## SECTION 009113.01 - ADDENDA

- A. Project Name: Spectacle Pond Water Treatment Plant – PFAS Treatment Facility.
- B. Owner: Town of Ayer.
- C. Owner Project Number: 20DPW-12.
- D. Engineer: CDM Smith Michaela L. Bogosh, P.E., PMP.
- E. Date of Addendum: September 2, 2020.

### 1.2 NOTICE TO BIDDERS

ELECTRICAL GENERAL NOTES

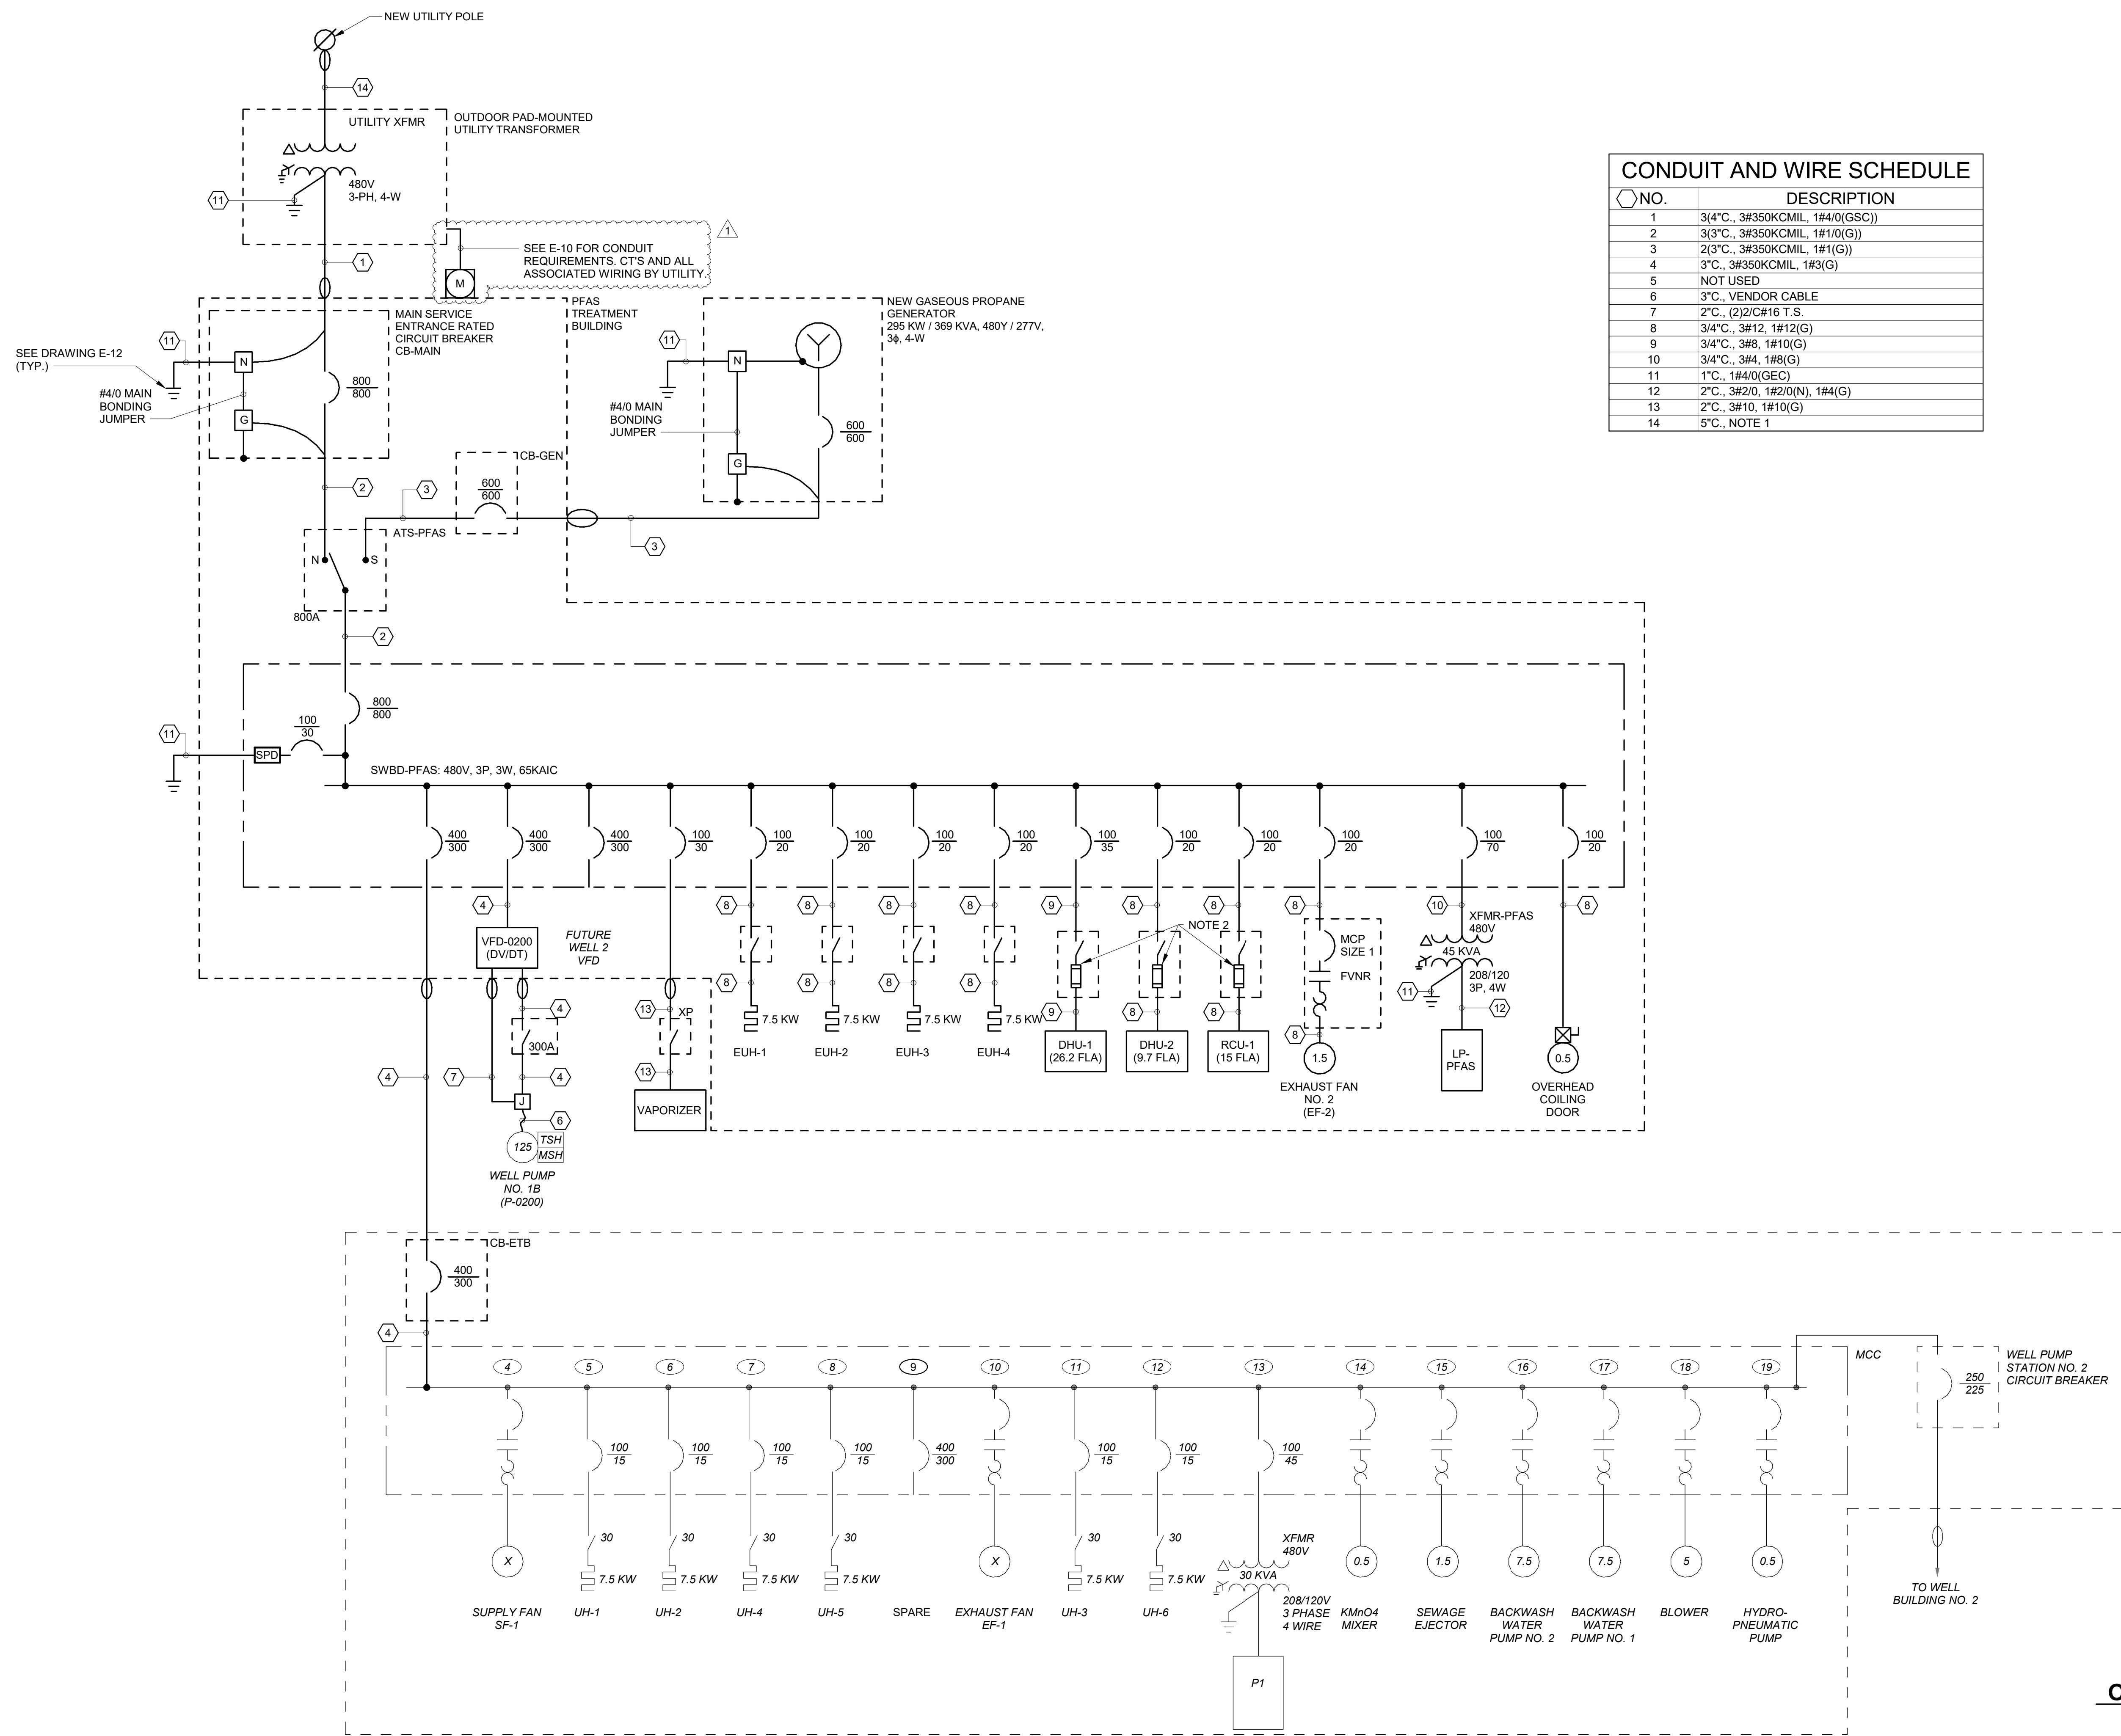
- COORDINATE WITH THE PCSS TO DEMOLISH EXISTING INSTRUMENT PANEL IN THE EXISTING TREATMENT BUILDING ELECTRICAL ROOM. MAINTAIN INSTRUMENT PANEL FUNCTIONALITY AND EXTEND SIGNALS TO MCP-SPEC. RELOCATE CHART RECORDER AS INDICATED ON SHEET E-8.
